Wintergreen Property Owners Association
Jay W. Roberts, *Executive Director*
Tel. 434 325 8531 Jroberts@wpoainc.org

June 12, 2018

RE: Sufficiency of the NWP 12 conditions related to sites VA AP-10237 (MP 158.7) and VA AP-10237 (MP 158.9)

Discussion of the Atlantic Coast Pipeline in the Reeds Gap – Pond Hollow Headwaters Area, Nelson County, Virginia

Wintergreen HDD Path

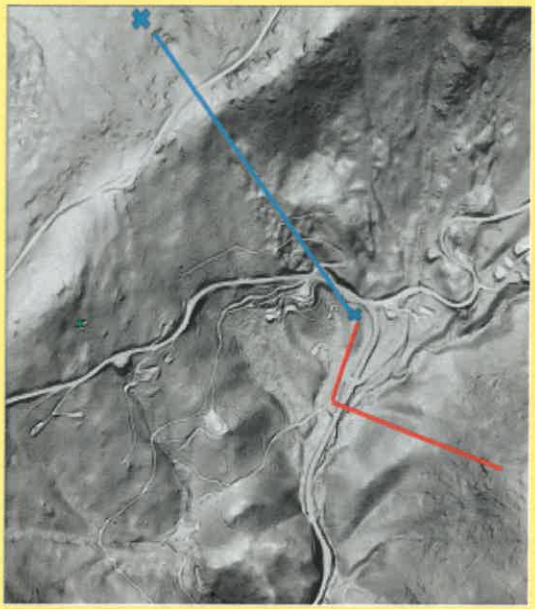
The following slides show the path of the ACP relative to the geology known to exist in the area.

Wintergreen Alternative HDD Path

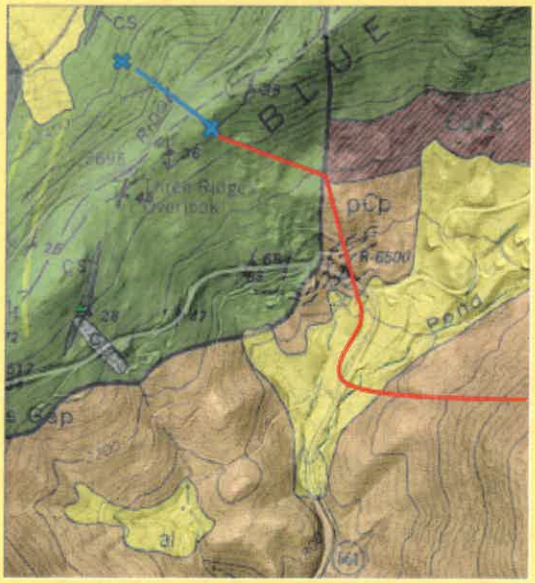
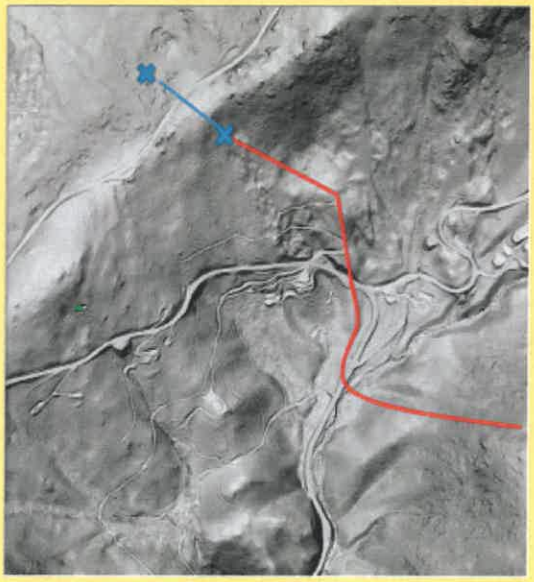
3) Lastly Wintergreen also provided LiDAR images that clearly show that multiple and recurrent landslides and debris-flows pose a serious natural hazard to the both ACP route and its alternate.

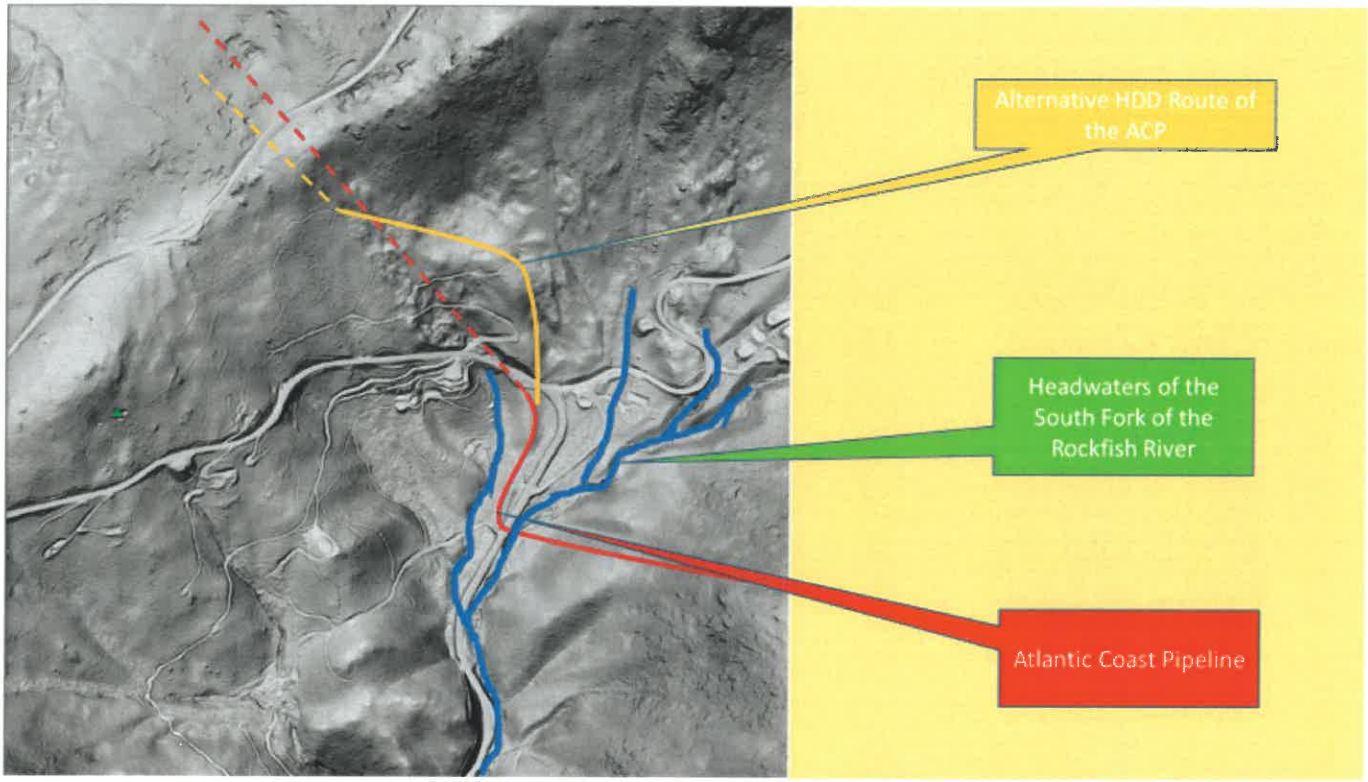
The Lidar image below shows the proximity of the ACP and the headwaters of the Rockfish River.

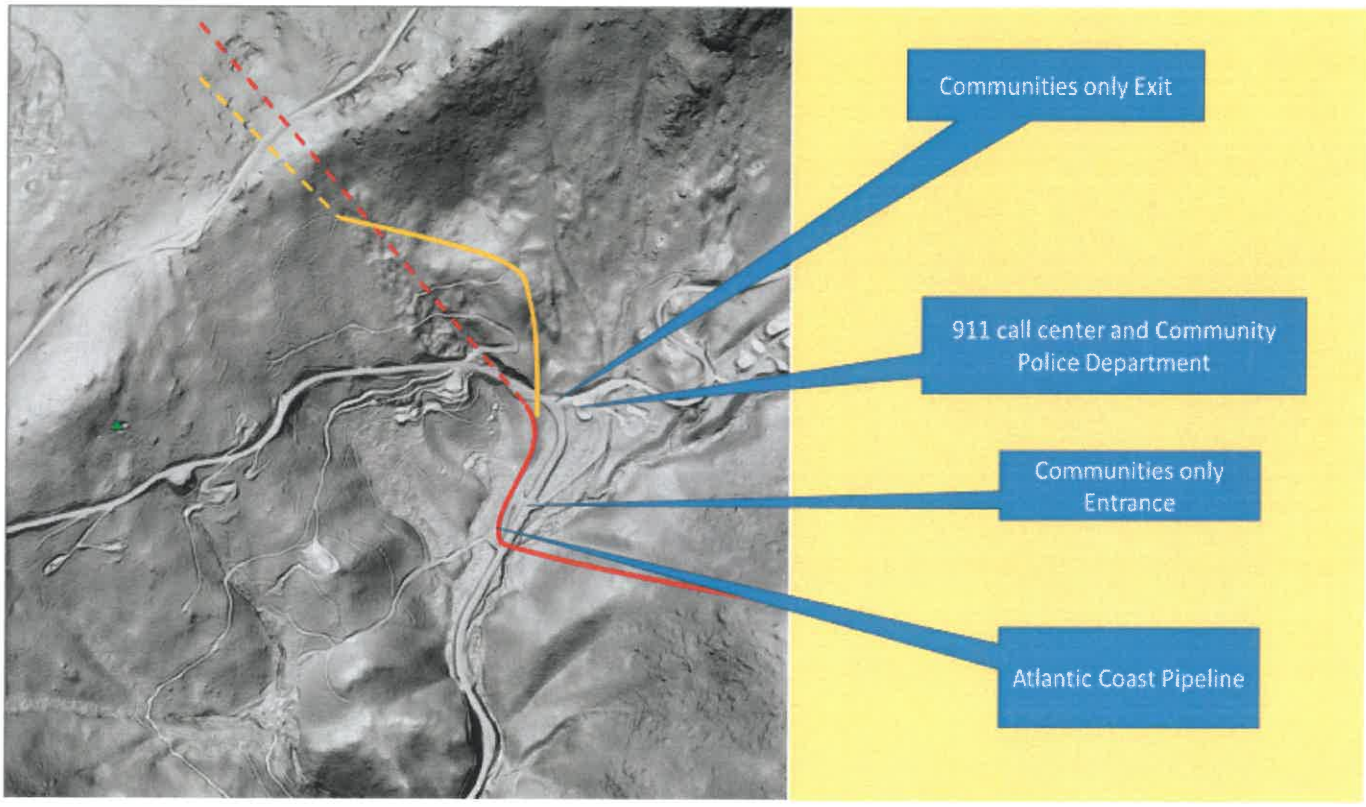
Careful review of the LiDAR images provided helps identify areas of instability, previous slide areas, the proximity of stream, roads, Wintergreen's only entrance and exit to these areas and the path of the ACP.

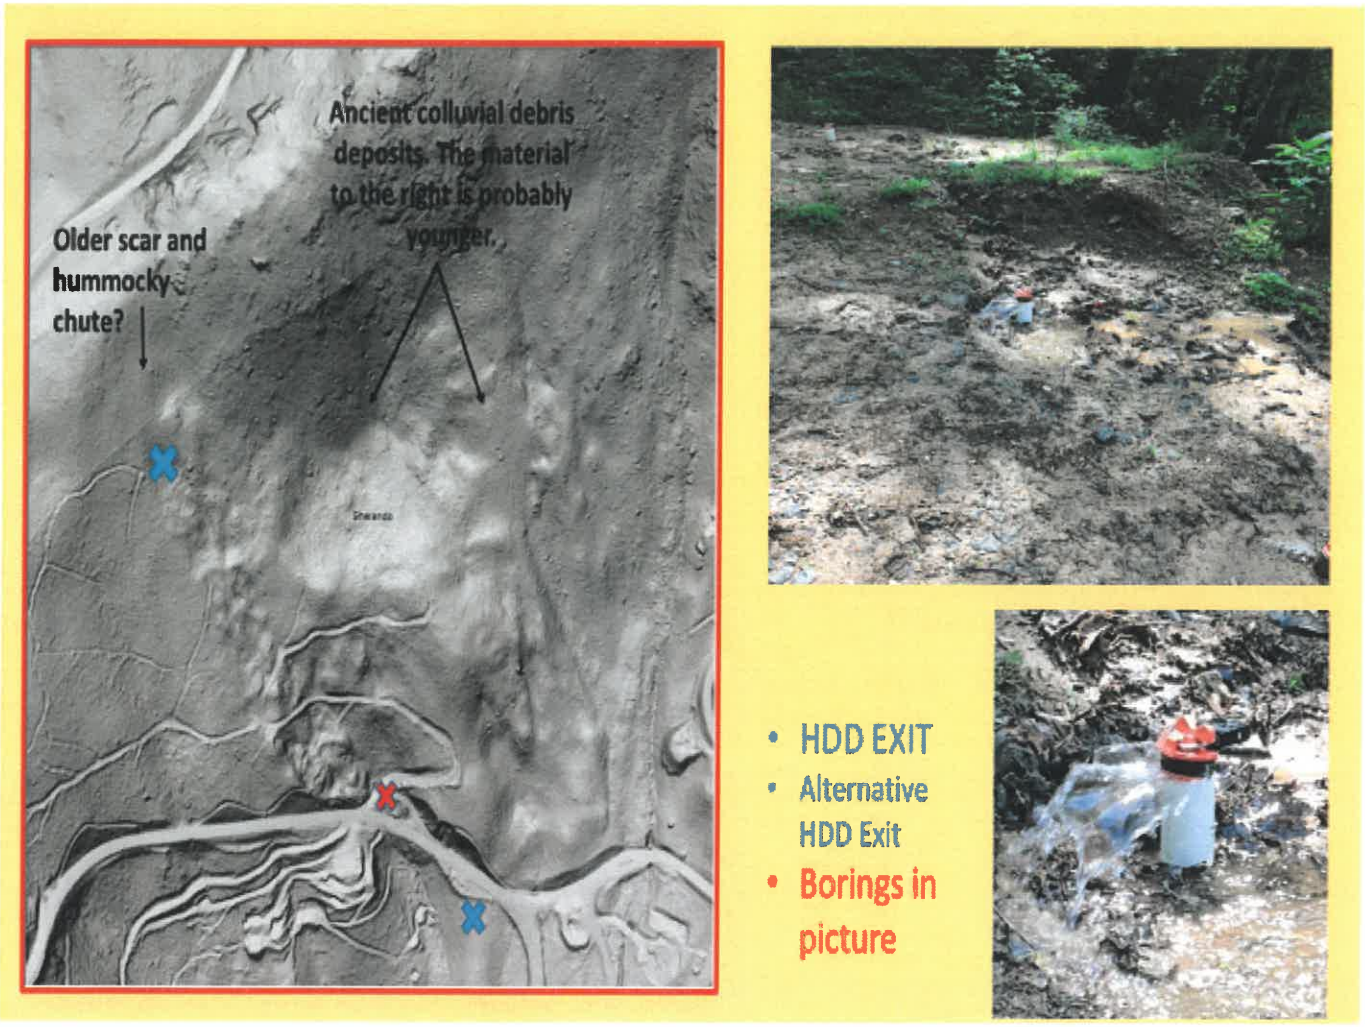
As part of the project planning, ACP conducted soil borings along the HDD path. These boring locations are easily found and as predicted in the reports shared, show clear evidence of significant ground water. The slide below references one of these boring locations and provides evidence of the extent of the ground water at risk AND the potential source for colluvial material destabilization.

As shown in the bottom right of the slide above, the borings in this area encountered water significant enough to force the pressure cap off the original bore hole. This one penetration of the faults identified in the geology report provides clear evidence of significant ground water under significant pressure. This water is currently uncontained and seeping into the colluvial material on a steep slope directly above the HDD site. This evidence and the knowledge that other borings along the HDD show signs of similar water challenges should be cause for concern for the ACP, DEQ, FERC, and the Corps. It is important to note that the Wintergreen Community uses the ground water held in these faults as an integral part of the community's potable water and fire protection supply. If the penetration of this potable water source by the HDD process; releases, contaminates, or in any way compromises this important well water source, an entire mountain community will suffer the negative impacts.
